## SERVICE LETTER No. L 136

**MODEL AFFECTED:** Z 242 L aircraft, S/N: 0682

**SUBJECT:** Aircraft manufacturer instructions for detected cracks and defects and repair instructions.

*Fig. No. 1*

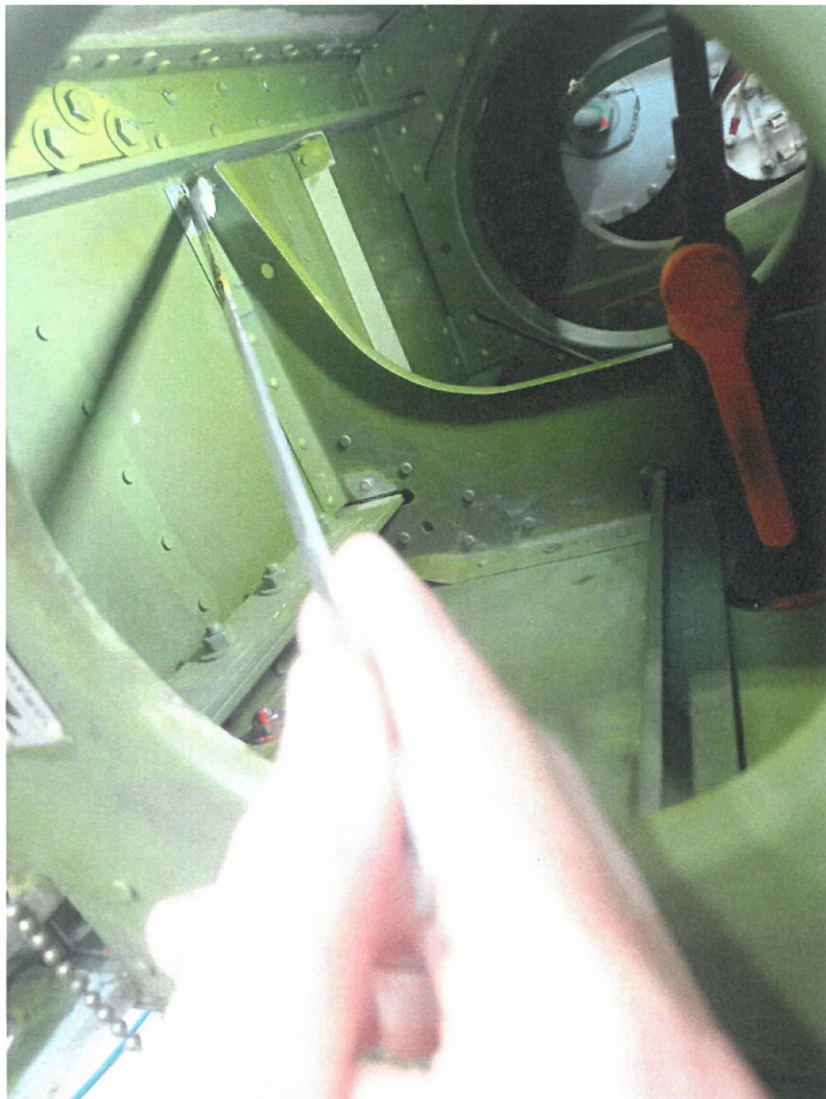
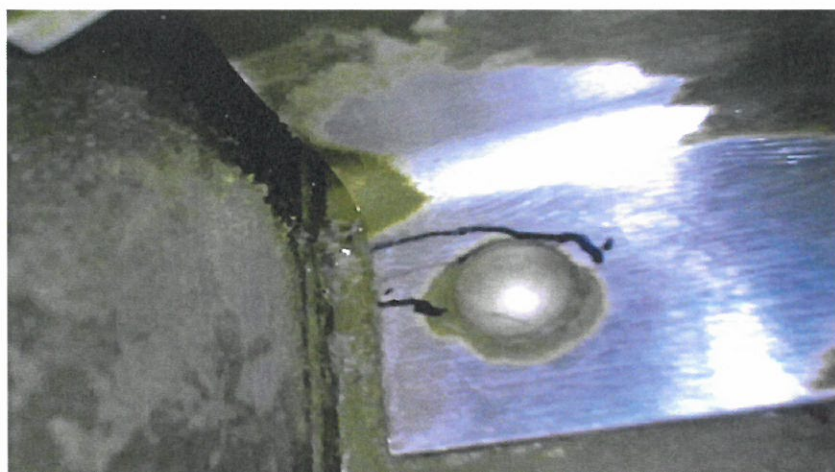
- 1) Second rib from both the left- and right-wing root. The length of the cracks is 4, resp. 2 mm (see Fig. 1 and No. 2).

1. Repair the rib cracks as described on pages 4-17 and 4-33 of the above-mentioned document. The final state of the repaired rib is as follows:

*Fig. No. 4*

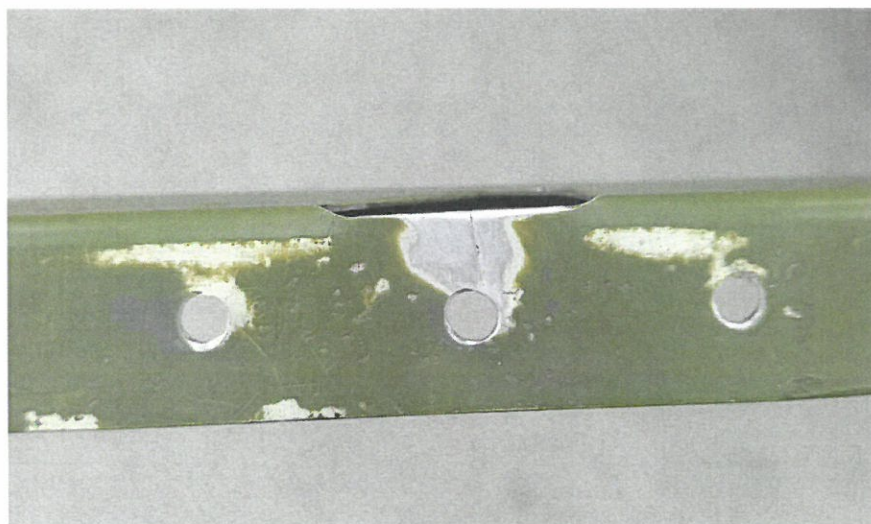
- 2) The rear part of the left root rib. The length of the crack is 3 mm (see Fig. No. 3 and No. 4.

- 2) Repair the rib cracks as described on pages 4-17, 4-30 and 4-37 of the above mentioned document. The final state of the repaired rib is as follows:

*Fig. No. 5*

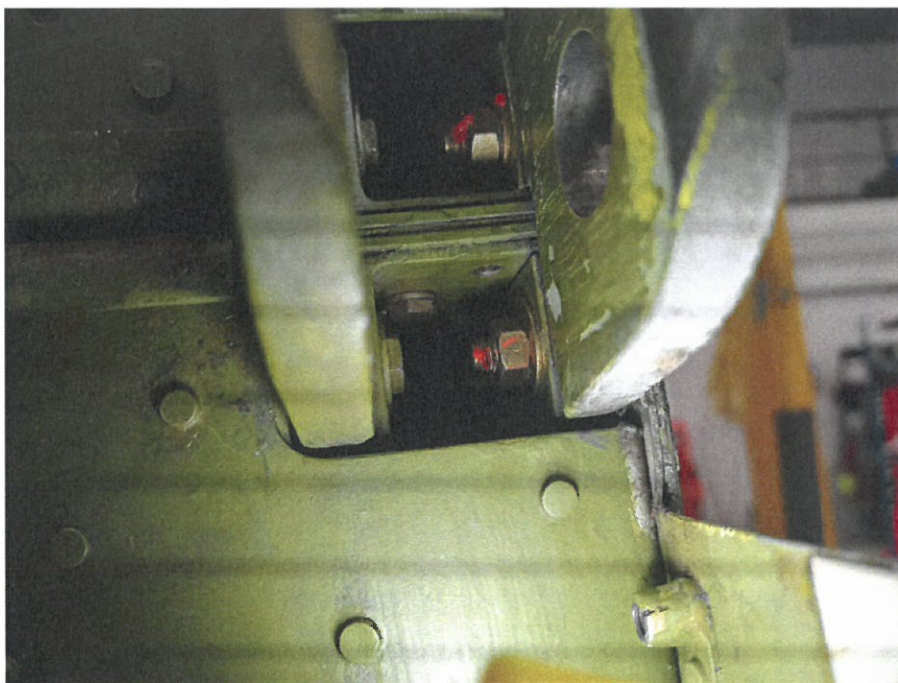
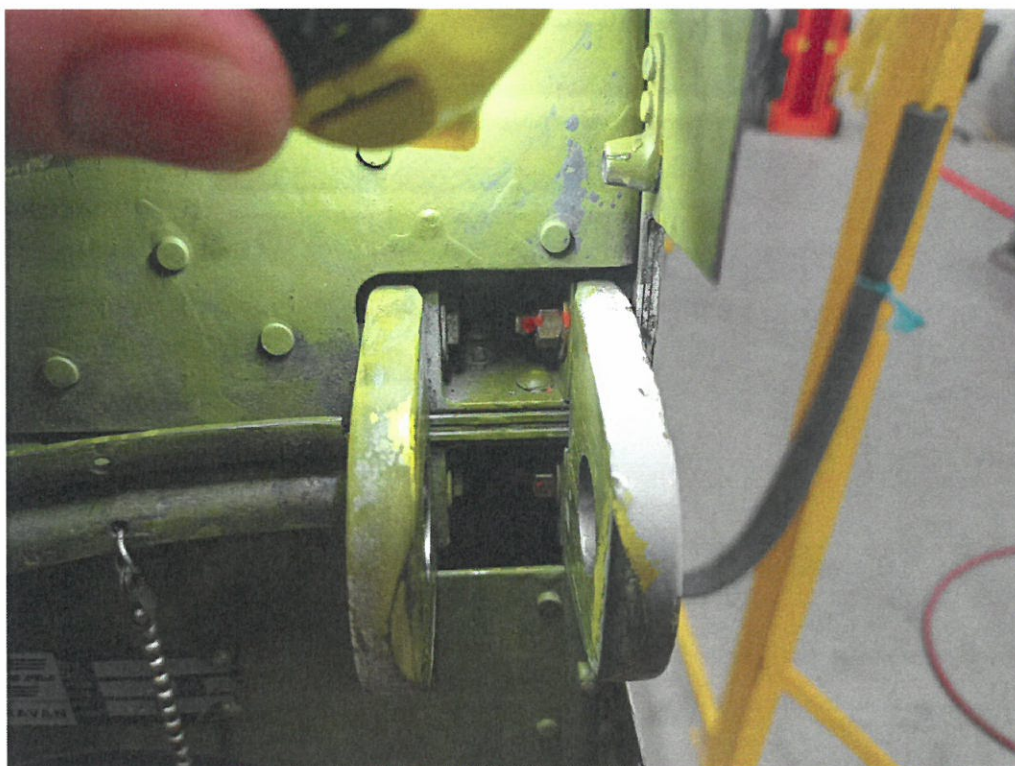
- 3) The sheared head of the technological rivet connecting the lower and upper plate of the main wing attachment point was found (see Fig. No. 5 and No. 6.).

- 3) Replace the sheared rivet by the bolt as described in Service Bulletin Z242L/20a issued by ZLIN AIRCRAFT a.s. on 6<sup>th</sup> June 1996.  
The rivet replacement for the screw must be performed on both wing attachments.
